International  
Civil Aviation  
Organization

Ref.: AN 7/1.3.94-09/46

**Subject:** Proposals for the amendment of Annex 10, Volume I, concerning instrument landing system (ILS) coverage requirements, global navigation satellite system (GNSS) signal-in-space performance requirements and GLObal NAVigation Satellite System (GLONASS) system requirements

**PROPOSED AMENDMENT TO ANNEX 10, VOLUME I**

**Figure C-7. Localizer coverage with respect to azimuth**

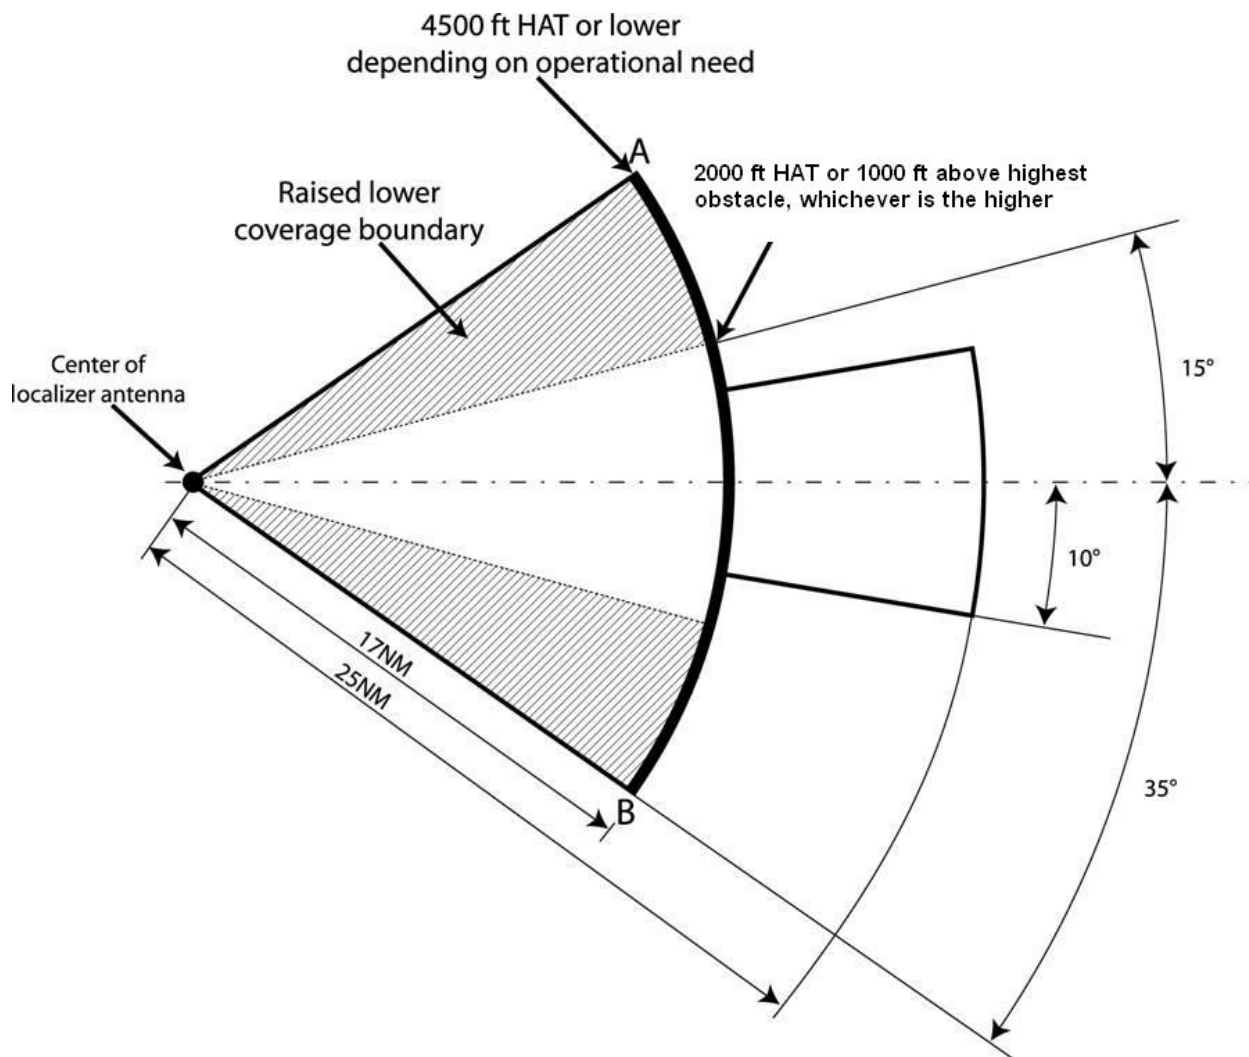
*Editorial Note.— Replace Figures C-7 and C-8 with the following figures.*

3.1.3.3.1 The localizer shall provide signals sufficient to allow satisfactory operation of a typical aircraft installation within the localizer and glide path coverage sectors. The localizer coverage sector shall extend from the centre of the localizer antenna system to distances of:

46.3 km (25 NM) within plus or minus 10 degrees from the front course line;

31.5 km (17 NM) between 10 degrees and 35 degrees from the front course line;

18.5 km (10 NM) outside of plus or minus 35 degrees **from the front course line** if coverage is provided;

except that, where topographical features dictate or operational requirements permit, the limits may be reduced to 33.3 km (18 NM) within the plus or minus 10-degree sector and 18.5 km (10 NM) within the remainder of the coverage when alternative navigational facilities **means** provide satisfactory coverage within the intermediate approach area. The localizer signals shall be receivable at the distances specified at and above a height of 600 m (2 000 ft) above the elevation of the threshold, or 300 m (1 000 ft) above the elevation of the highest point within the intermediate and final approach areas, whichever is the higher, except that, where needed to protect ILS performance and if operational requirements permit, the lower limit of coverage at angles beyond 15 degrees from the front course line shall be raised linearly from its height at 15 degrees to as high as 1 350 m (4 500 ft) above the elevation of the threshold at 35 degrees from the front course line. Such signals shall be receivable, to the distances specified, up to a surface extending outward from the localizer antenna and inclined at 7 degrees above the horizontal.
